## Grandview Reserve Phase 2 Preliminary Drainage Report

December 2023

HR Green Project No: 201662.202

EDARP Filing No.:  
PUDSP236

## APPENDIX D – WATER QUALITY & DETENTION

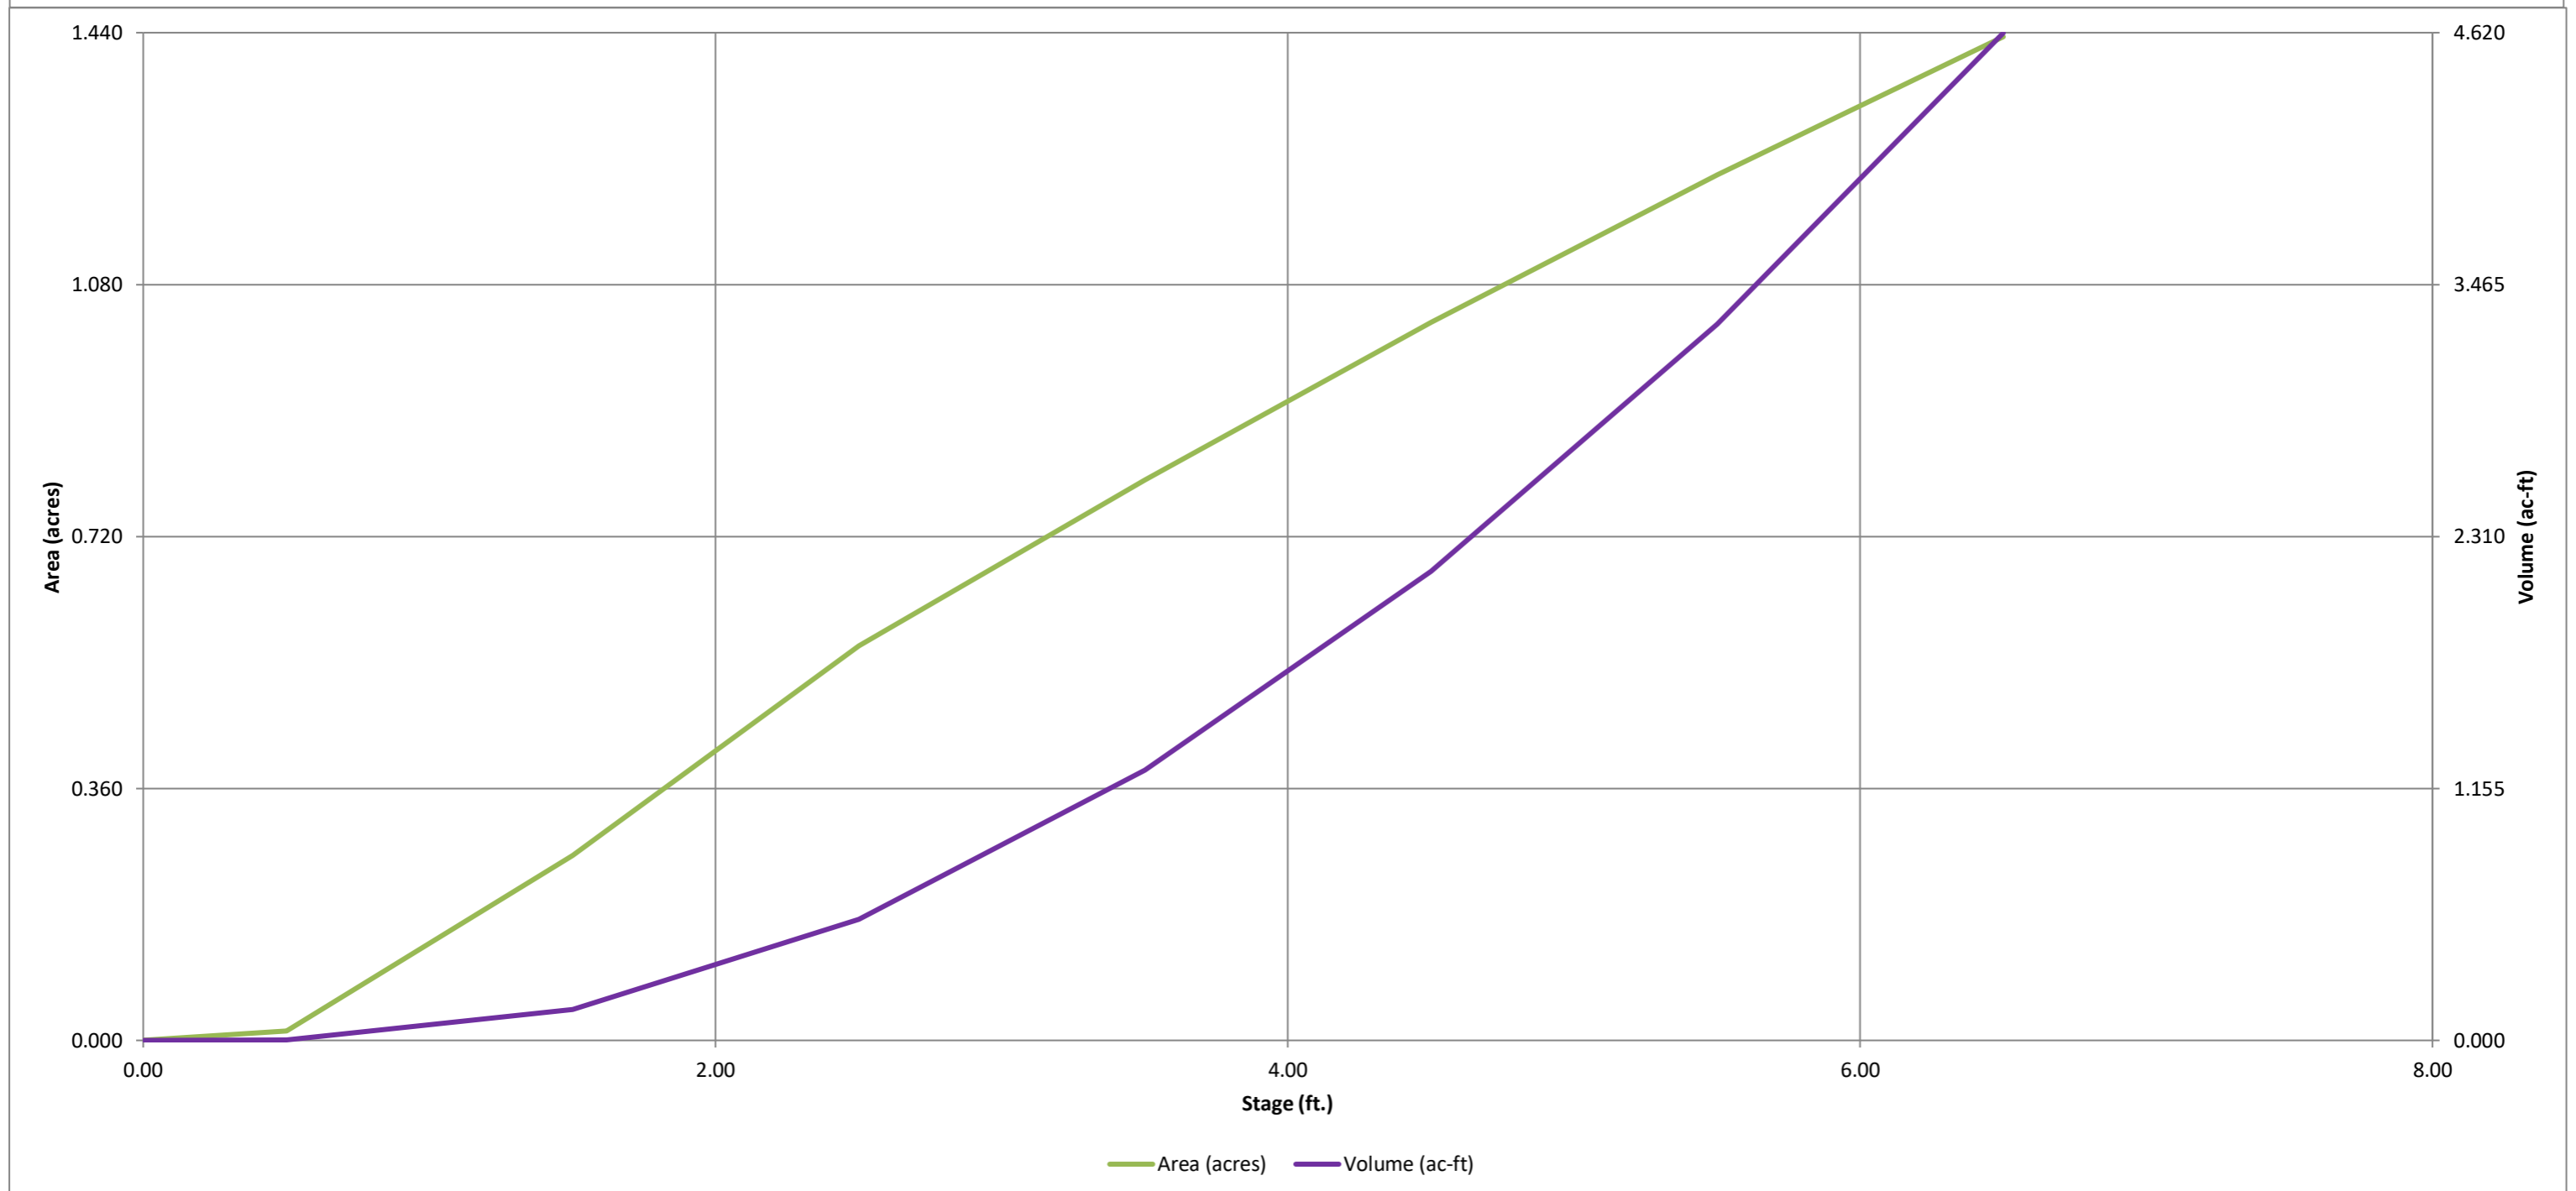
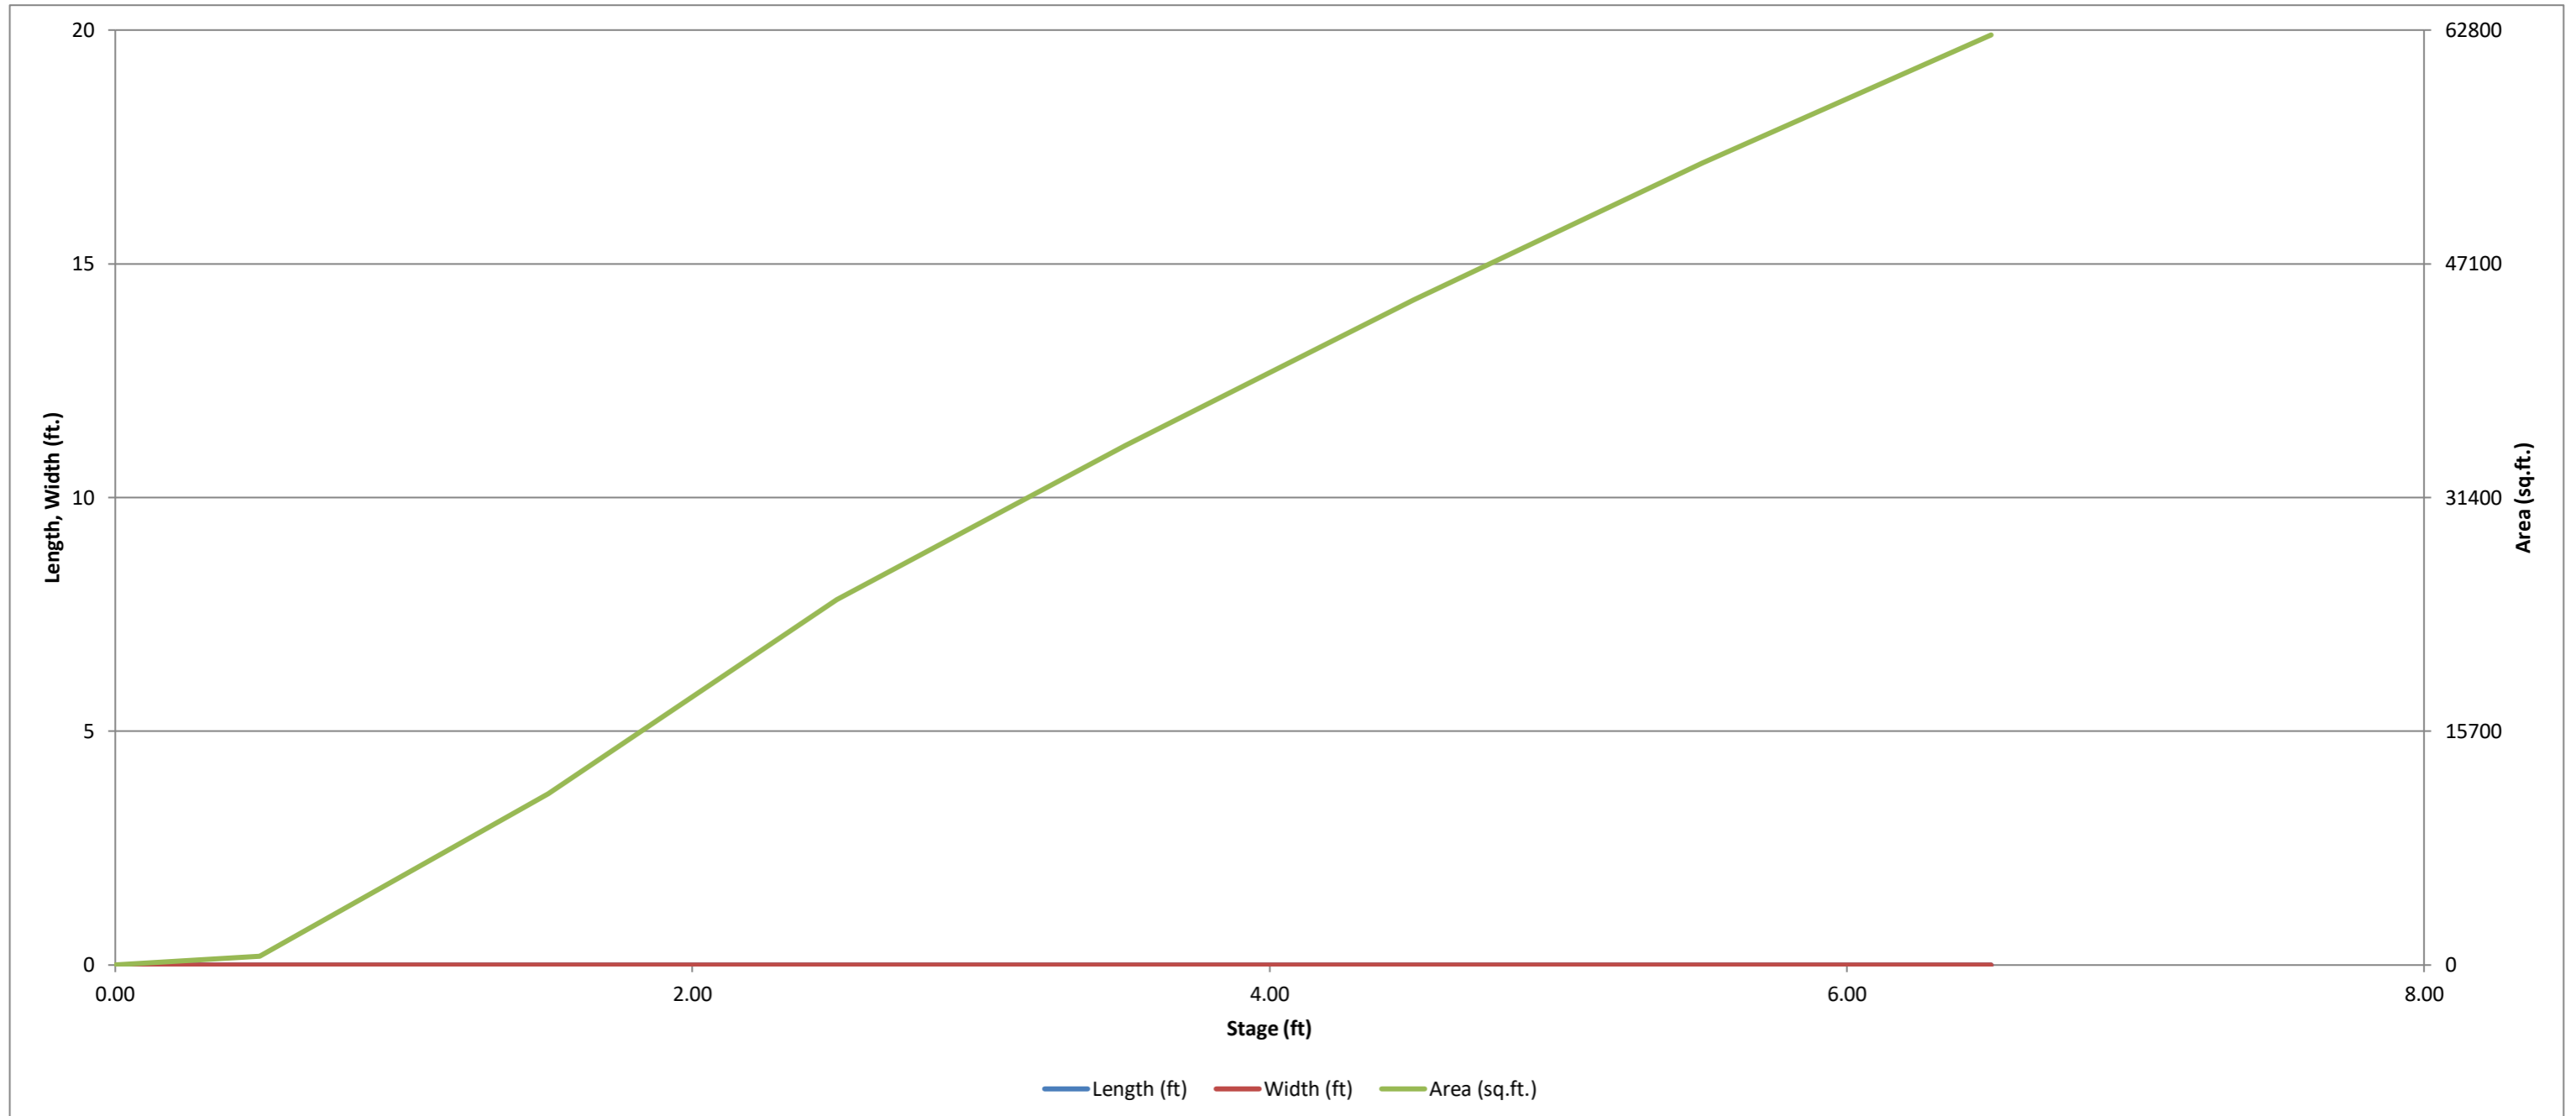
Note that the pond calcs will be reviewed in more detail with the FDR and subsequent submission of CDs. Can't do a full review of these calcs without the pond details in the CDs.
